Request for Information – Local Government Official Information and Meetings Act (LGOIMA) 1987

BC No: BC210296

Property Address: 221 High Street – Hutt Central

Apartment Conversion
 Construction Documentation
 221 - 223 High St.
 Lower Hutt
TAD WORKS
 TAD works Ltd
 Level 1/85 Waterloo Road, Lower Hutt
 T: 04 - 856 9600 / M: 0273103404
 E: andrew@tadworks.co.nz

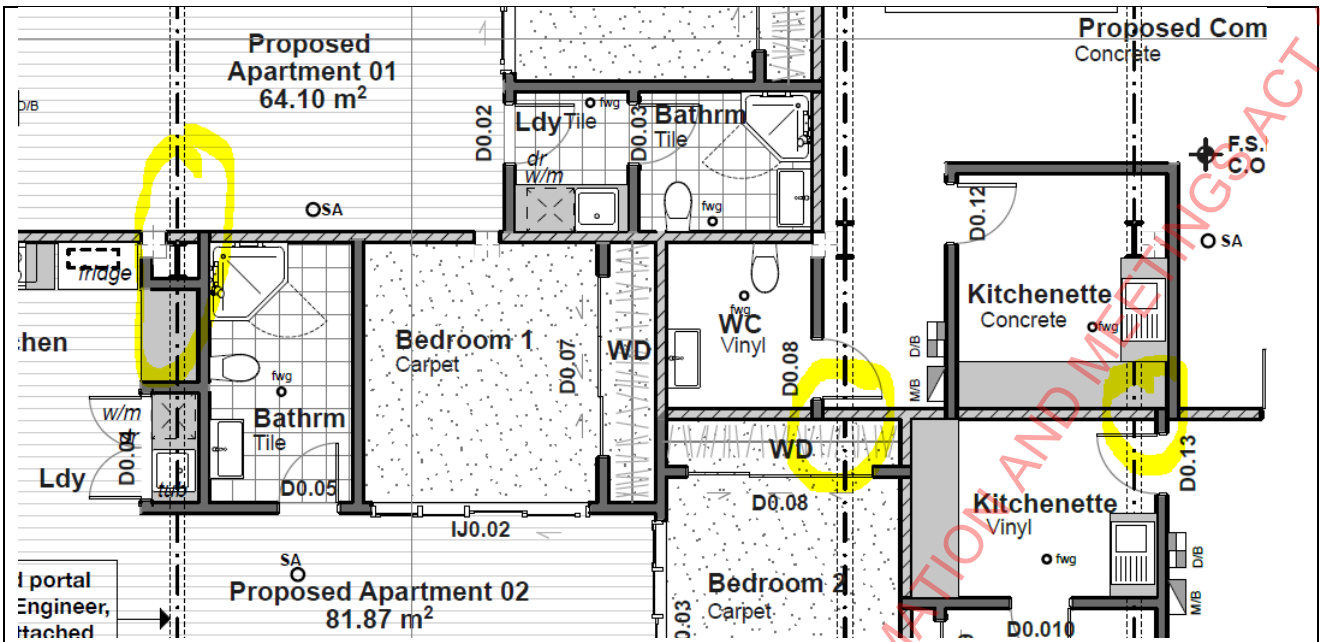
Upper level apartments have shared single escape route. Longest DEOP for apartments is 18m (table 3.2 states 30m) OK till shared escape reached(safe path) The safe path is fully protected till the exitway to outside TOP well less than limit. Other criteria for single escape path are: Occupancy less than 50 yes, escape ht less than 10m yes, no basement levels, smoke lobby top precede vertical escape path – n/a as the ground floor tenancies do not have access to the lobby at the bottom of the stairwell OK. other SM specific factors – people with disabilities less than 10 yes, the safepath must comply with 3.9.4 to 3.9.11 – check this, safe path is fire separated and less than max length of table 3.4 OK. Final exit door is a sliding door? Is this acceptable. In addition clause 3.9.9 requires a fire door between the safe path and the vertical safe path. Check

Doors SD1.01 to SD1.05: These are shown on the fire report as requiring a 60 minute fire rating. Please provide a manufacturers specification for all proposed fire doors including evidence of a -/60/60 fire rating. Please add this information to the door and window schedule. Please include manufacturers installation details for fire and smoke doors showing head and jamb details as required. Please revise the internal door schedule to include the manufacturer of the doors, the particular model or type, and their proposed FRR ratings.

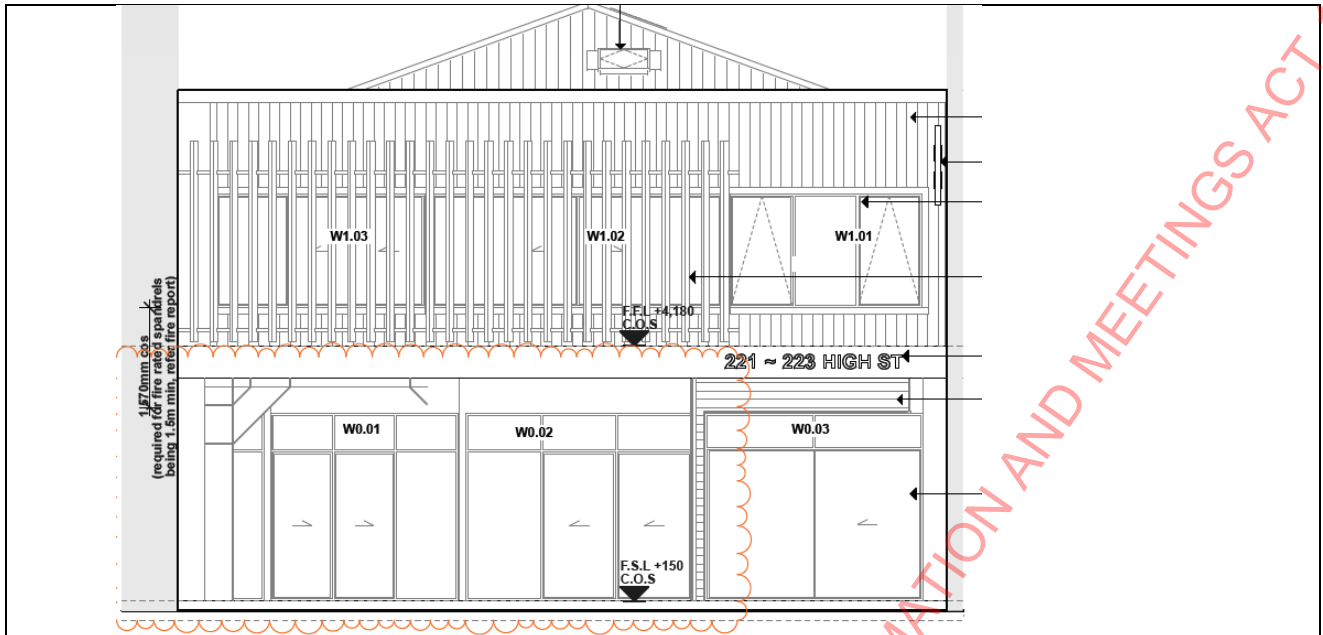
- Please dimension the height of the barrier above FFL. Please provide construction details and show fastening details to the building, and label materials to be used. Please demonstrate how these barriers comply with F4 as the gaps in horizontal members appears to allow for climbing.
- If a proprietary system please provide product information (including installation details) and include a PS1(issued within 12 months) from the manufacturer.

Based on the Southern elevation (see below) sliding windows to apartments 5 and 6 open more than 100mm and protection from falling is provided by aluminium louvres. Is this correct? Please demonstrate how these louvres provide an F4 compliant barrier in particular show a Dia100mm sphere would be unable to be dropped from these open windows. Check this one as the veranda is there if you fell.

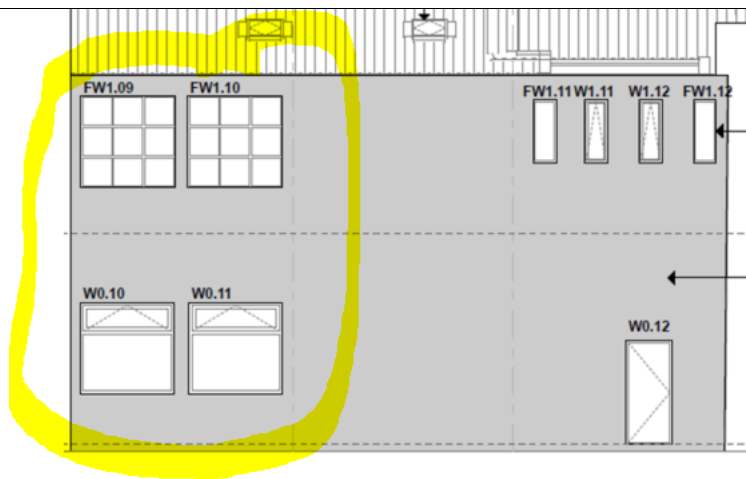
10. Based on the plans supplied windows FW1.09, FW1.10, W0.10 and W0.11 are new replacement windows in walls within 1m of the boundary. Therefore please demonstrate how the proposed glazing is compliant with C/AS2 clause 5.2.4. Based on table 5.1 the maximum permitted size of fire resistant glazing is 1m² and figure 5.1 requires a separation distance between adjacent FR windows of at least the width of the wider window being installed. (see below) Question not answered by Fire Engineer in a way I can understand. Phone call to designer. Please note windows FW1.09 and FW1.10, W0.10 and W0.11 are located on or not far from the boundary.

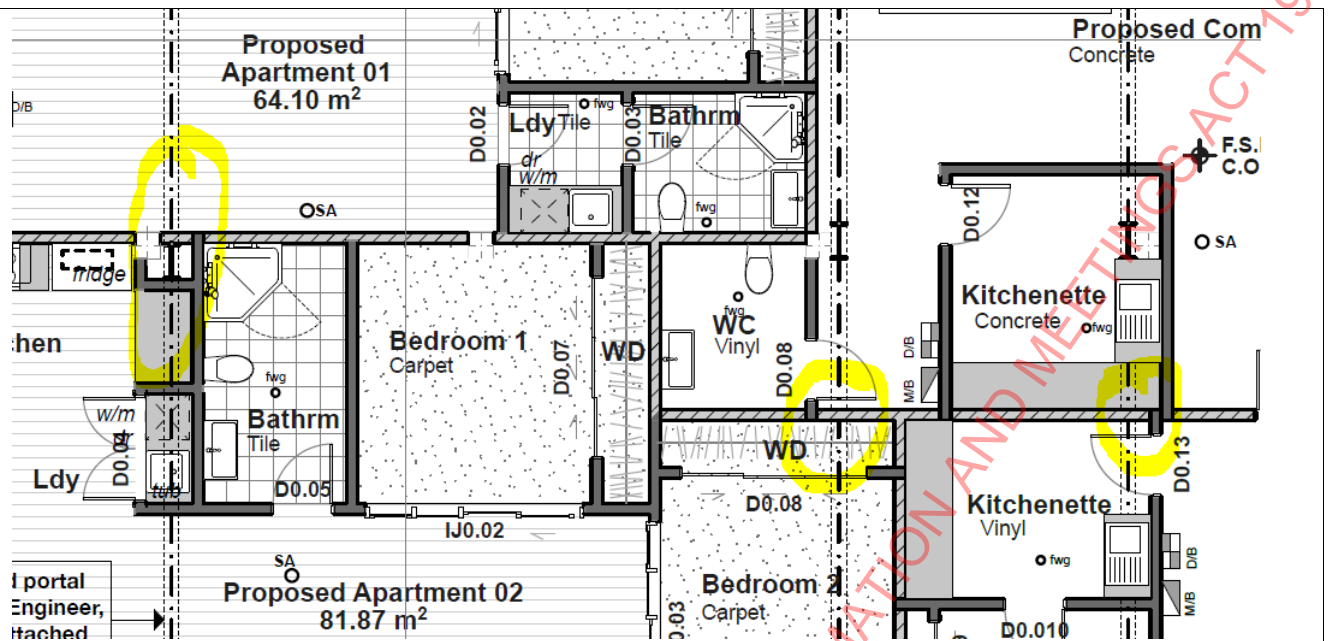
We can confirm that the ground floor portal frames don't need to be fully fire rated. The main gravity supports are still the existing concrete beams and columns. If the portal frames were damaged by fire, it will not cause any stability issue.

15. Please provide details showing steelwork penetrations through fire separations in particular how the integrity of the fire separation is to be maintained. (see below) RF1 response received 14/7/2021 contains a note stating that HILTI 606 fire stopping sealant to be used where steel penetrates the GIB FR walls – need to see data sheet for the HILTI 606 sealant. Does the ceiling to apartments 1 and 2 means that the beam penetration through the walls is within this protected area? is the purpose of the GIB 45min ceiling to mean the beam penetrations through the walls above this ceiling do not need to be fire rated?

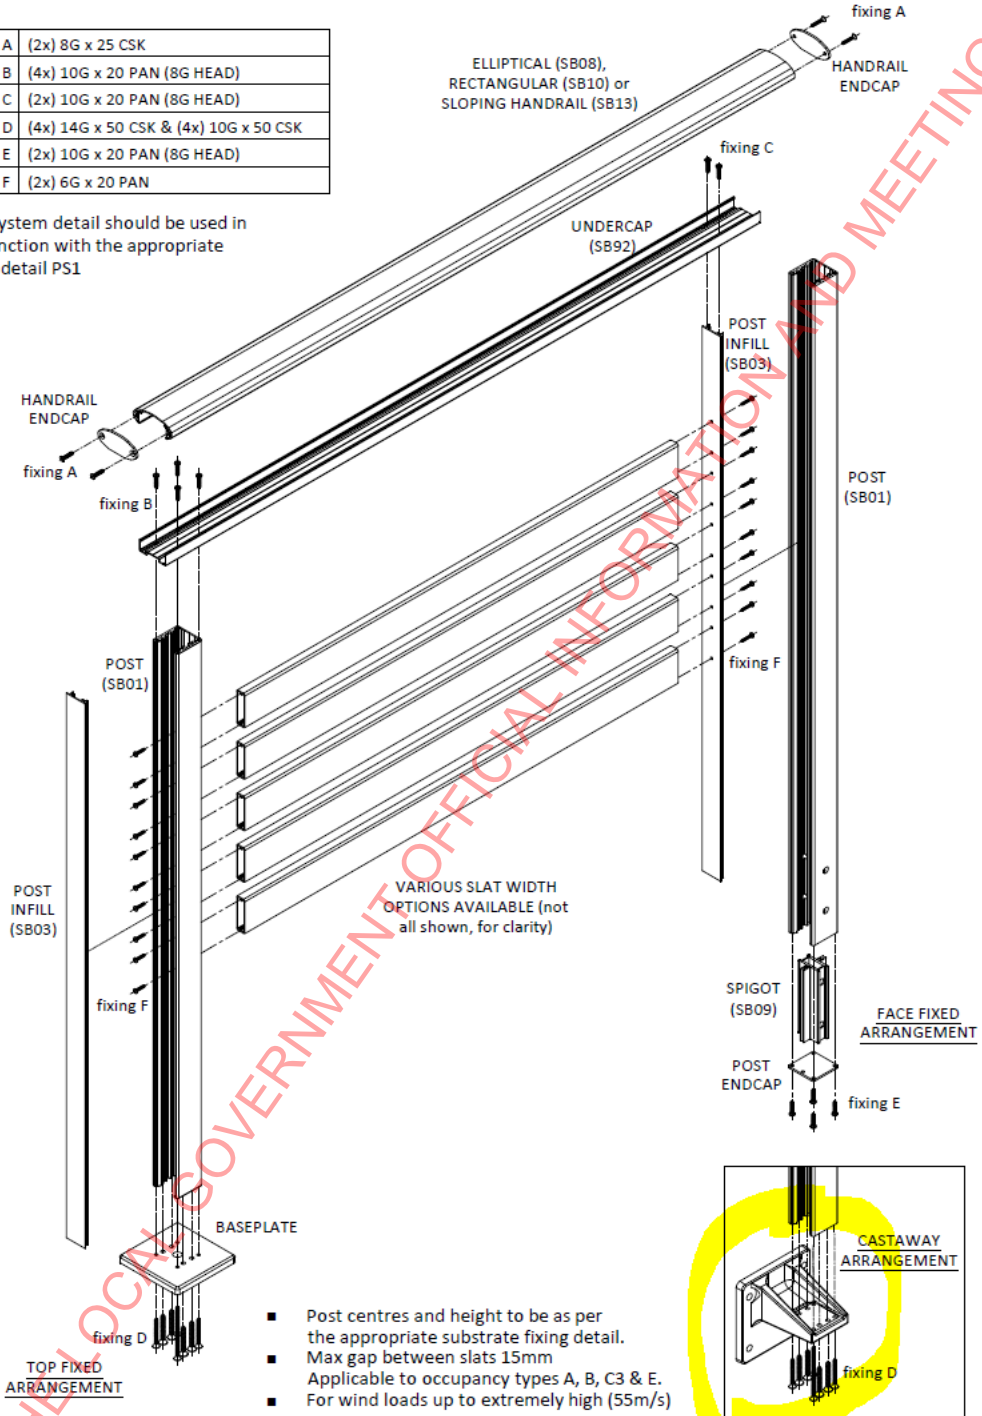
and sheet BL.2.1.9 does not specify this fixing.

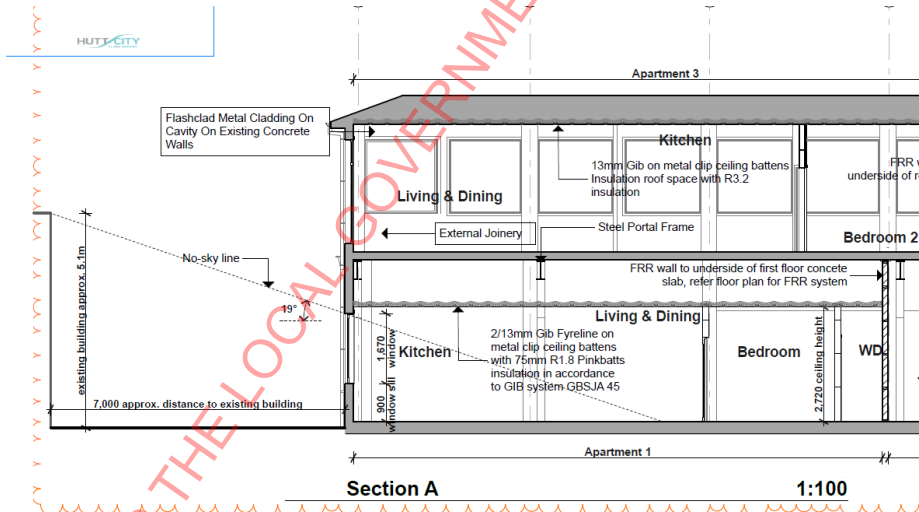
Apartment 1: This apartment has just 1 external wall with windows.

- 55. Please demonstrate (by providing a cross section showing window heights) how the bedroom (habitable space) complies with the requirement for visual awareness of the outside environment. RFI 1 response received 14/7/2021 contains a cross section showing the room see below I cannot see how G7 is met for this bedroom.

- 56. Please demonstrate (by providing a cross section showing window heights) how the head height for windows complies with G7/AS1 part C. Please note a window area in excess of 10% of the floor area may be necessary. See above
Please also demonstrate whether the no sky condition applies for external glazing. If it does please provide a schedule of surface finishes for the floor ceiling and walls so high reflectance surfaces can be seen as per G7/AS1 clauses 1.02 to 1.04 See above

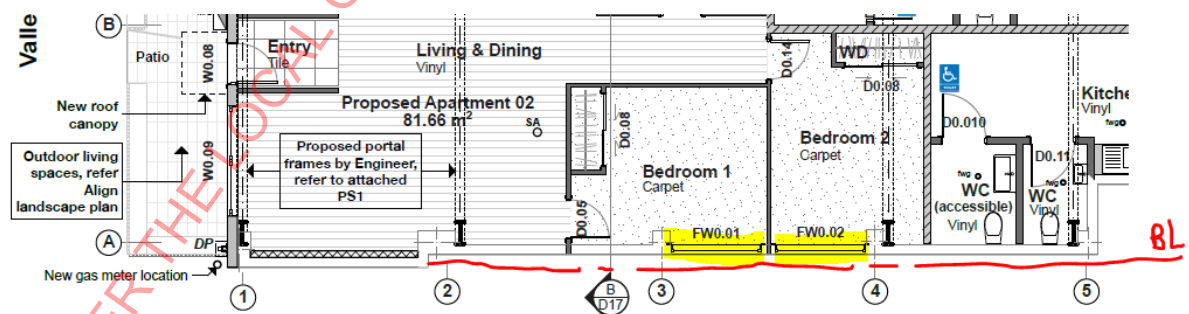
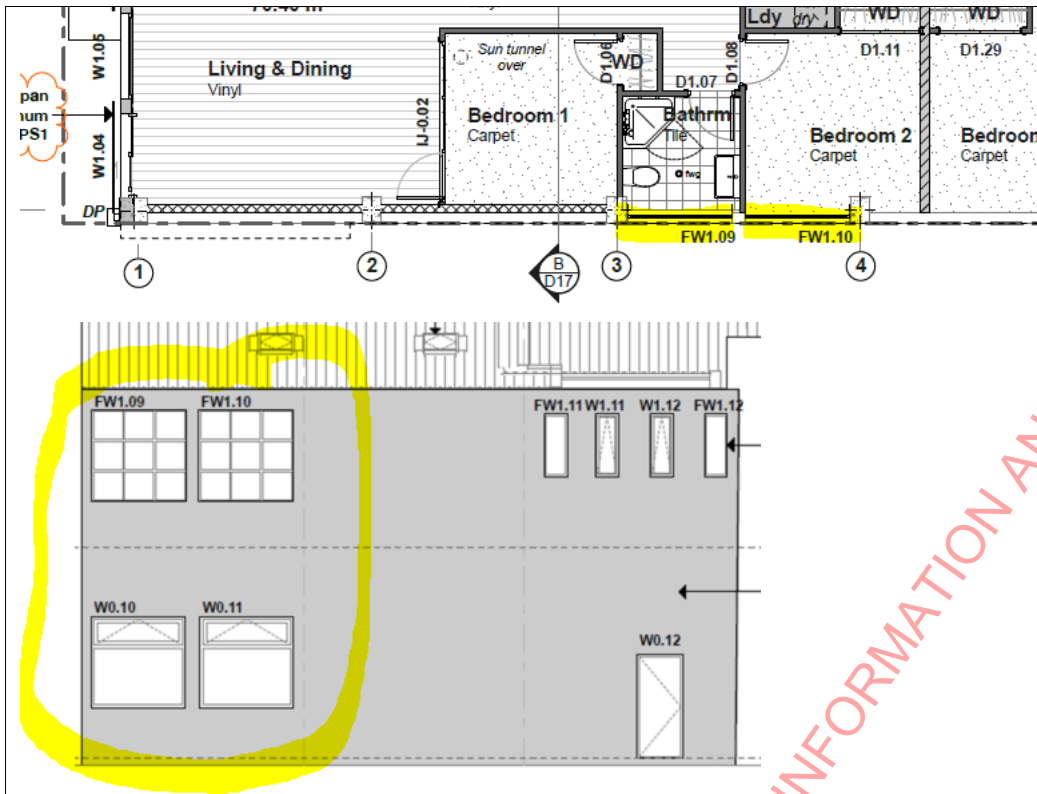
Original RFI Question 4: Proposed type 4 and type 5 alarm systems. Please provide a layout plan from a suitably qualified person showing all detectors by type, sounder locations, location of the manual call point/s and fire alarm panel. Please provide evidence that Fire and Emergency have approved the proposed location for Multi Zone fire alarm panel as per NZS 4512:2010 Paragraph 403.1 This question not answered.

Please provide a layout plan from a suitably qualified person showing all detectors by type, sounder locations, location of the manual call point/s and fire alarm panel. Ask discussed with fire Engineer, It is intended to undertake the fire alarm install on a design build basis as is typical for projects of this scale. The fire alarm will be subject to

independent certification of the design and install. Please provide evidence that Fire and Emergency have approved the proposed location for Multi Zone fire alarm panel as per NZS 4512:2010 Paragraph 403.1 RFI2 response received 23/9/2021 contains a Fenz approved plan showing Fire Alarm Panel location provided.

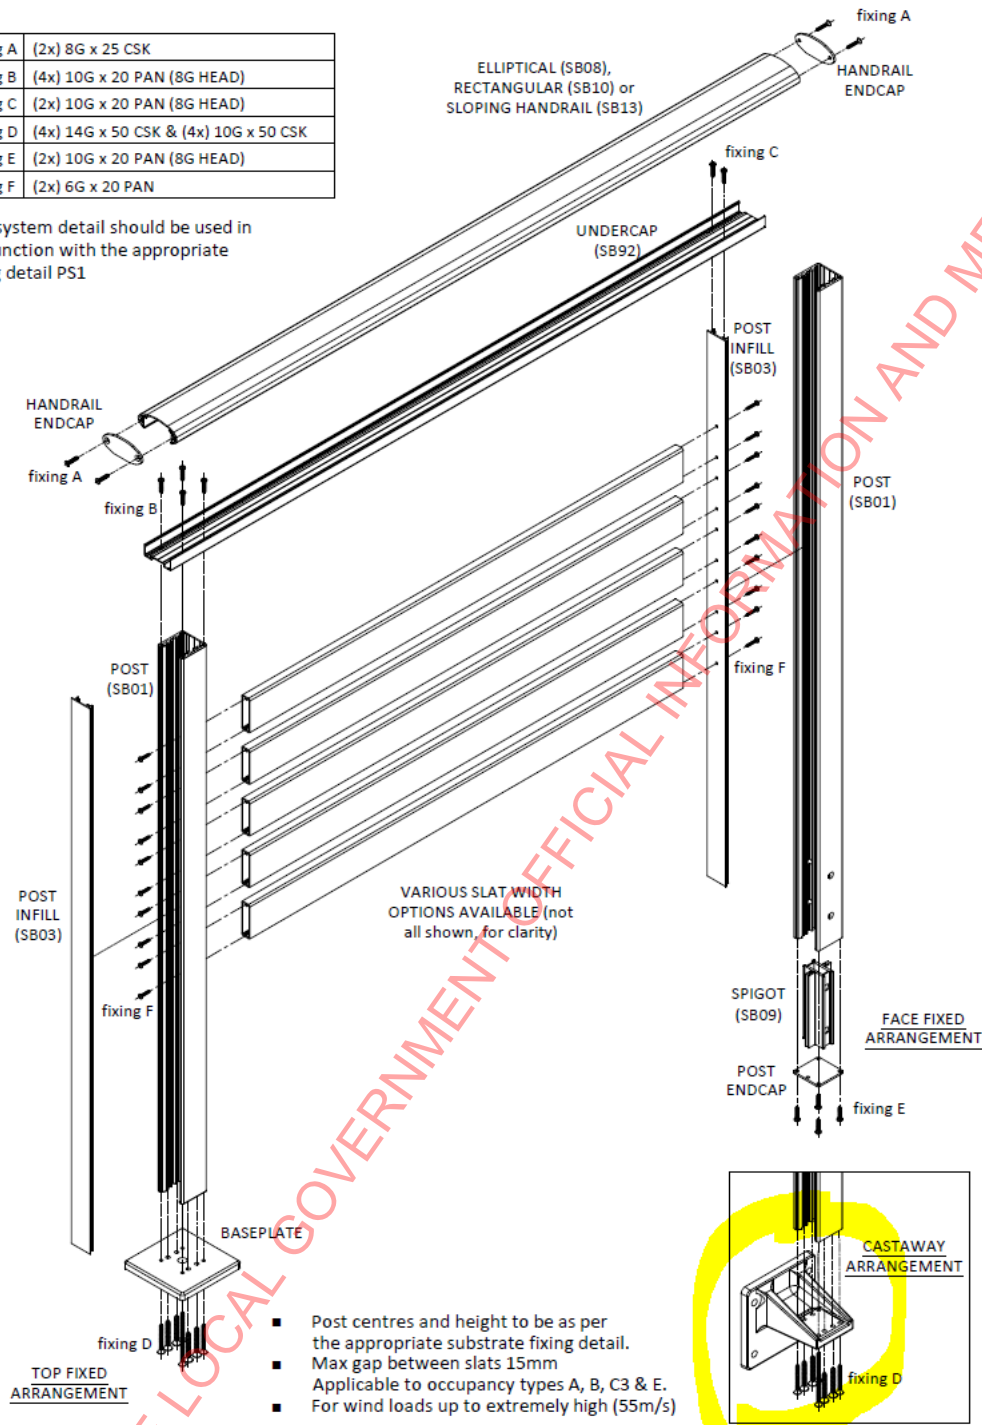
Further Question: Please provide fixing details for the Clearspan infill and the exterior wall. The PS1 supplied and sheet BL.2.1.9 does not specify this fixing. RFI1 response received 23/9/2021 contains a fixing detail and (generic) PS1 to cover this detail for the fixing of the cast away bracket. The generic PS1's supplied for the entrance canopy and the horizontal slat system state they are valid for a BC issued 2 years after date on the PS1's which are 2020 so acceptable however the PS1 for the castaway bracket is dated 16/8/2019 and should be updated.

Further Question: Please provide fixing details for the Clearspan infill and the exterior wall. The PS1 supplied and sheet BL.2.1.9 does not specify this fixing. RF11 response received 23/9/2021 contains a fixing detail and (generic) PS1 to cover this detail for the fixing of the cast away bracket. The generic PS1's supplied for the entrance canopy and the horizontal slat system state they are valid for a BC issued 2 years after date on the PS1's which are 2020 so acceptable however the PS1 for the castaway bracket is dated 16/8/2019 and should be updated. Updated PS1's supplied answering this question.
